# North Carolina 2018 Draft 303(d) List Public Comment NC Division of Water Resources Responsiveness Summary

Submitted to EPA March 14, 2019

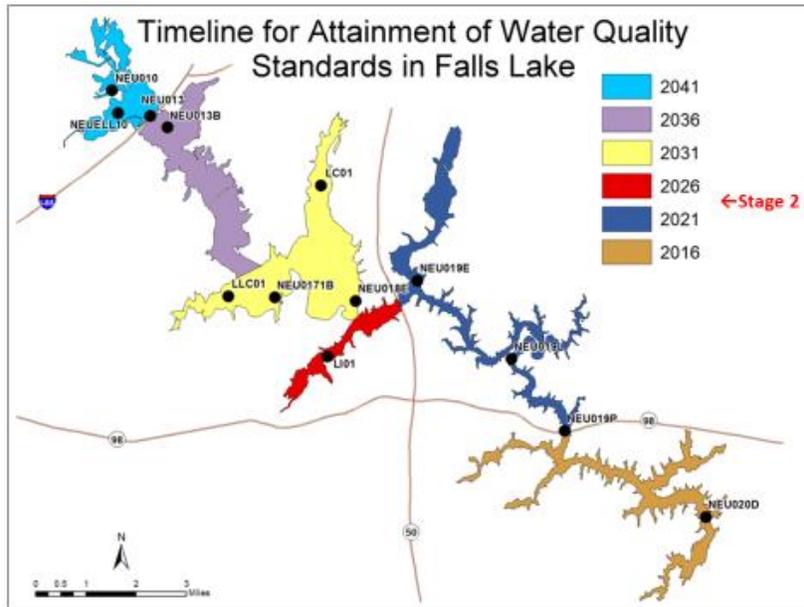
In contrast to the overly divided 11 AU segments found in the Draft 2018 IR, the Falls Rules, designed to attain the chlorophyll-a water quality standard, divided the lake into 6 consistent assessment units as depicted below. The UNRBA recommends and urges that Falls Lake AU's should be consistently applied, independent of individual parameter concentrations and based on *a priori* knowledge, morphometric, and limnologic features consistent with EPA guidance. In this manner, individual monitoring stations within an AU can each contribute information and data to a larger sample size more representative of the central tendency of the AU. The current approach of delineating AU's may be appropriate for small, free-flowing streams and rivers because monitoring stations are rarely in close proximity on the same water body. However, applying the current DWR

AU delineation process based on individual stations alone is not appropriate for Falls Lake - one of the most heavily monitored lakes in the country. In regard to the data richness of Falls Lake, the current AU assignment process actually discourages the collection of more data both within the lake and elsewhere. The DWR and the EMC are encouraged to avoid a “one-size-fits-all” approach in the assignment of AU’s for streams, rivers, lakes, reservoirs, and estuaries based on individual station evaluations. This approach is not valid for lakes, reservoirs and estuaries where more data is available and is clearly inappropriate for Falls Lake. AU’s need to be based on the principles identified and advocated in these comments.

Figure 1. NCDEQ 2016 Final 303(d) Map

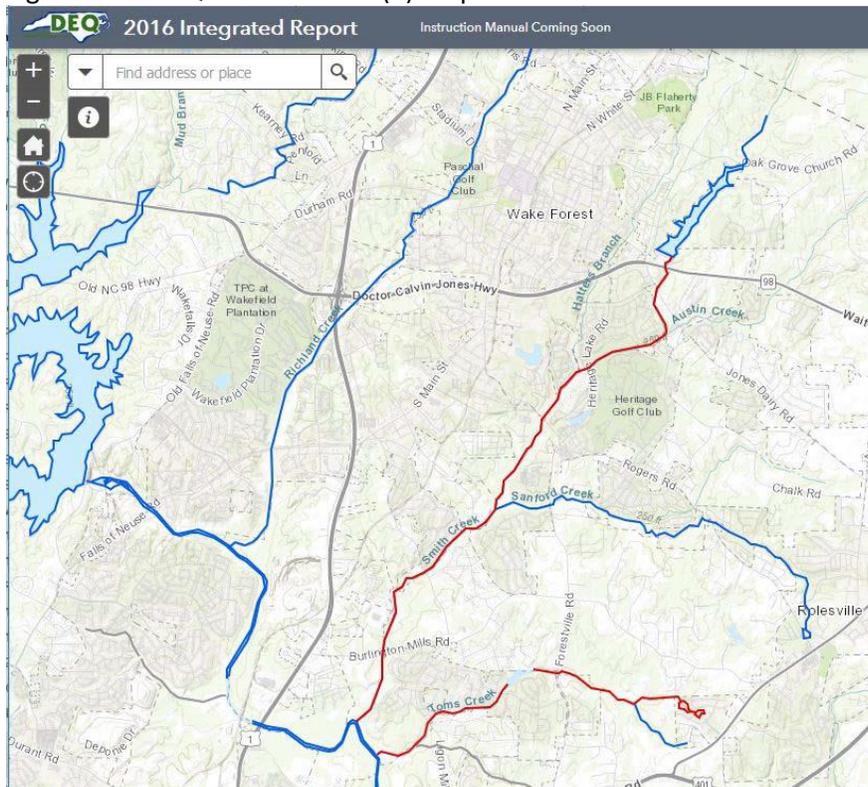
1. Extent of proposed impairment reach described in the 2018 draft list does not match the 2018 draft map:
  - a. The final 2016 303(d) list showed Smith Creek's Assessment Unit (AU) number as 27- 23-(2). Its description was "from dam at Wake Forest Reservoir to Neuse River." DEQ's map showed the extent of impairment as described (Figure 1). Its reason for rating was poor bioclassification, with Benthos based on narrative criteria to protect aquatic life in fresh water (Nar, AL, FW) shown as its parameter of interest.

Figure 2. NCDEQ 2018 Draft 303(d) Map

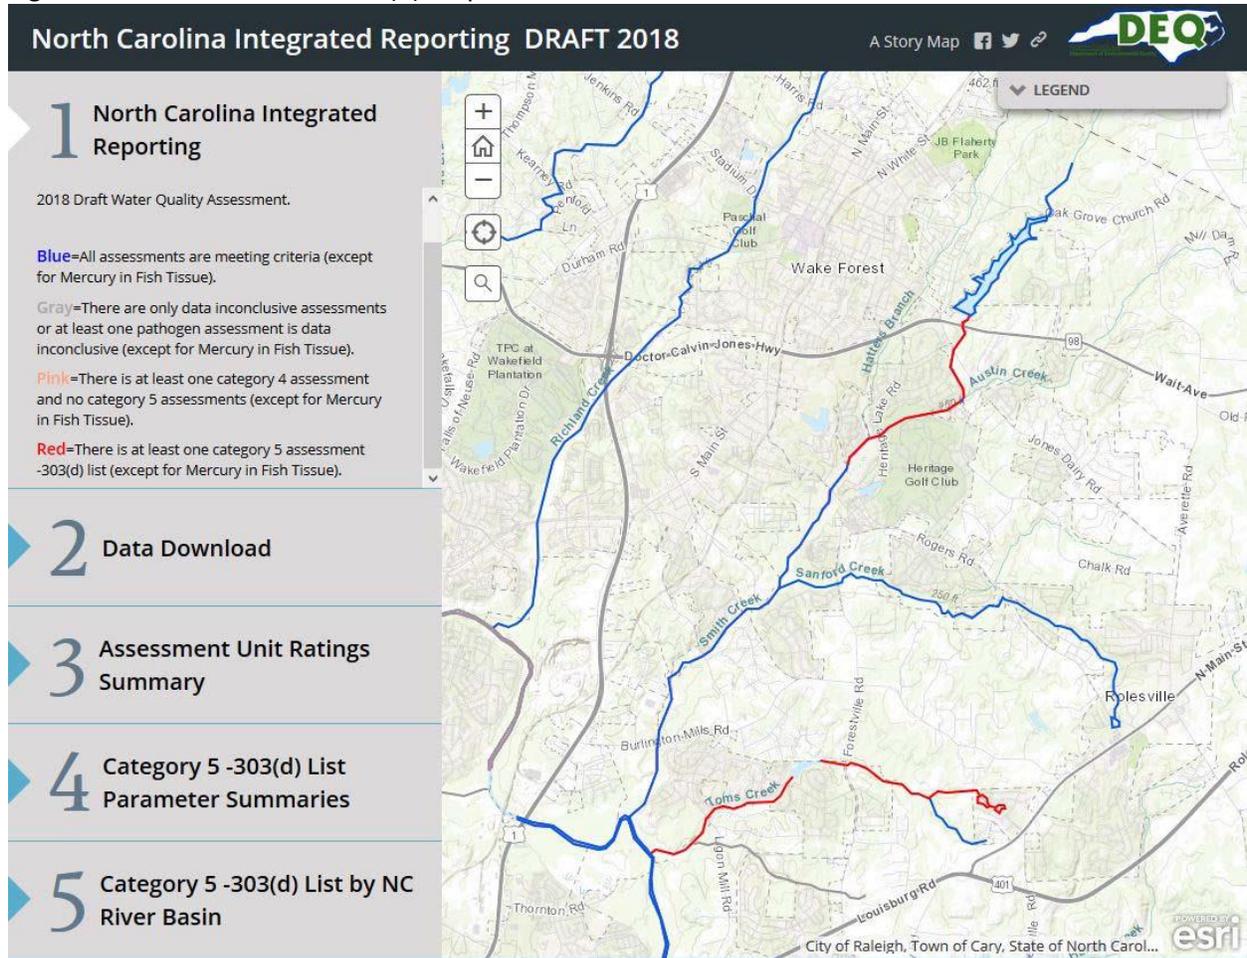
- b. The draft 2018 303(d) list shows Smith Creek's AU as 27-23-(2)a. Its description is the same as 2016: "from dam at Wake Forest Reservoir to Neuse River." DEQ's 2018 draft map (Figure 2) does not show the extent of impairment as described. Specifically, it shows the impaired

reach (in red) from the Wake Forest Reservoir Dam to a point approximately 2,200 stream feet downstream (southwest) of Heritage Lake Road. It also shows the balance of Smith Creek (downstream from this point to the Neuse River) as supporting (in blue: Figure 2). The 2018 draft map shows the impaired reach's AU the same as the draft 2018 list (i.e. 27-23-(2)a). It shows the supporting reach's AU as 27-23-(2)b. The impaired reach's reason for rating, both on the draft map and in the draft list is "poor bioclassification," with Benthos based on narrative criteria to protect aquatic life in fresh water (Nar, AL, FW) shown as its parameter of interest.

4. The stream reach from Heritage Lake Road, downstream to its confluence with Hatters Branch is not accurately depicted in the both the draft 2018 impaired waters map (Figure 2) or in the benthic sample location map (Figure 3).

Figure 3. DWR Water Science Section Benthic Sample Location Map

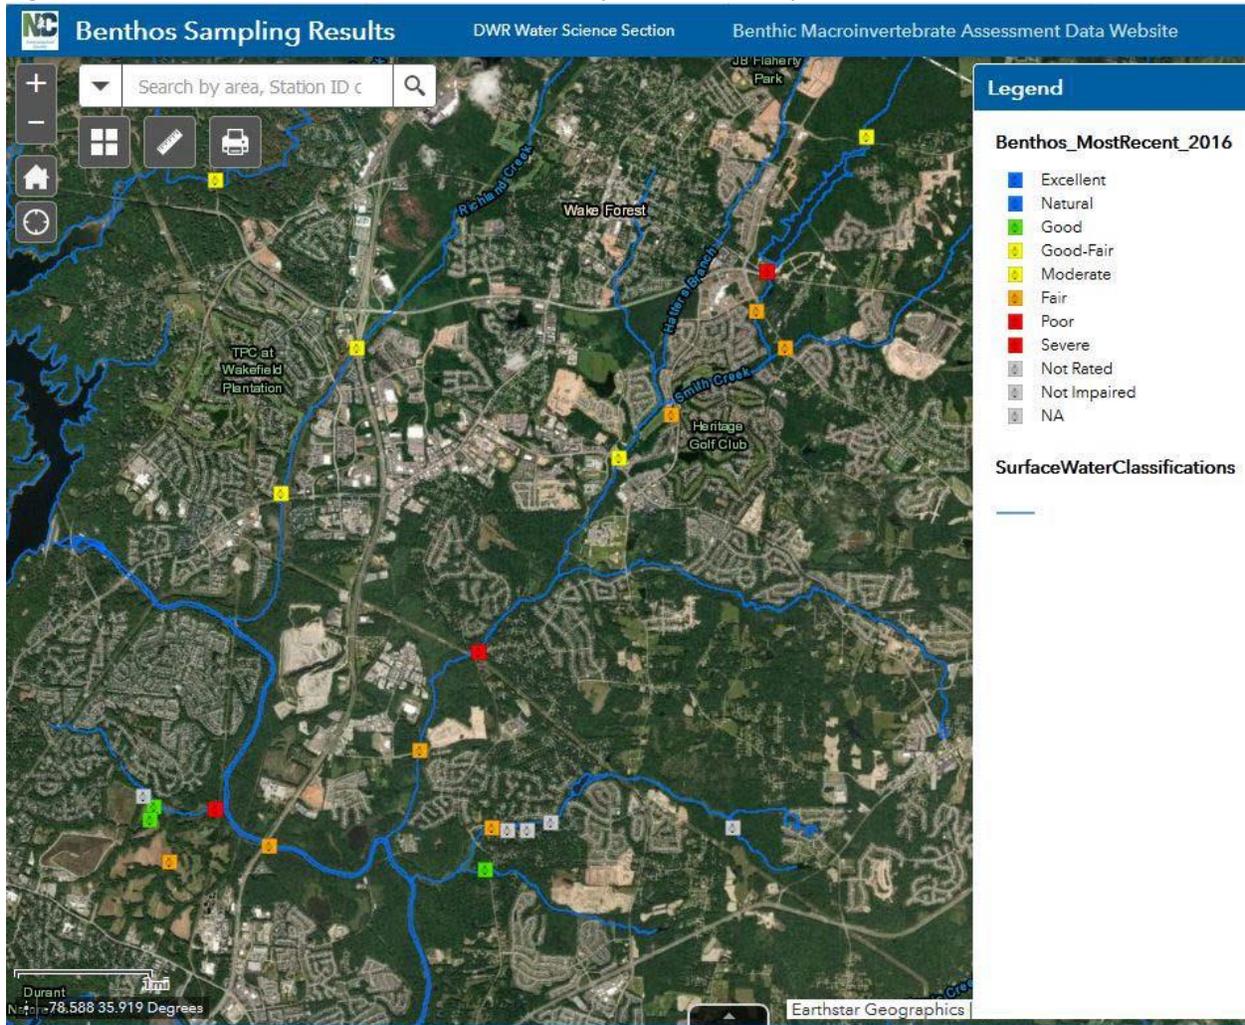
2. Benthic data do not match the impaired reaches described in the draft 2018 list or extents or ratings shown in benthic results map:
  - a. Both the 2018 draft list, as well as the 2018 draft map show the reason for rating as poor and the parameter of interest as Benthos (Nar, AL, FW). The DWR Water Science Section website map shows four sample sites within the impaired reach (AU 27-23-(2)a: Figure 3).

- i. The most recent sample at Site JB344 (31 May 2016), which is located immediately downstream of the Wake Forest Reservoir Dam, is shown with a Fair bioclassification (note that it is shown on the Figure 3 map as having a Poor (red) bioclassification). The site's 1 July 2014 sample's bioclassification was Poor.

3. Conditions in some of the stream reaches sampled do not reflect conditions within the extent of the impaired reach:
  - a. Benthic Sample Site JB344, as shown in Figure 3, is located between Wake Forest Road and the Wake Forest Reservoir's spillway and normal low flow outfall. In addition to being steep and rocky (both natural and artificial) along approximately the upstream half of this reach, there is significant disturbance and ongoing maintenance throughout. The majority of the balance of Smith Creek's channel downstream of Wake Forest Road, to and including its confluence with the Neuse River, has a sand/silt/gravel-dominated substrate.

- b. Benthic Sample Site JB345, as shown in Figure 3, is located within a stream reach that was significantly modified, as part of a NC Division of Mitigation Services (DMS, formerly the Ecosystem Enhancement Program (EEP)) project. DMS monitoring reports (<https://deq.nc.gov/about/divisions/mitigation-services/dms-projects>) indicate/document ongoing bed and bank erosion within the reach sampled (Sta 26+00-29+00).
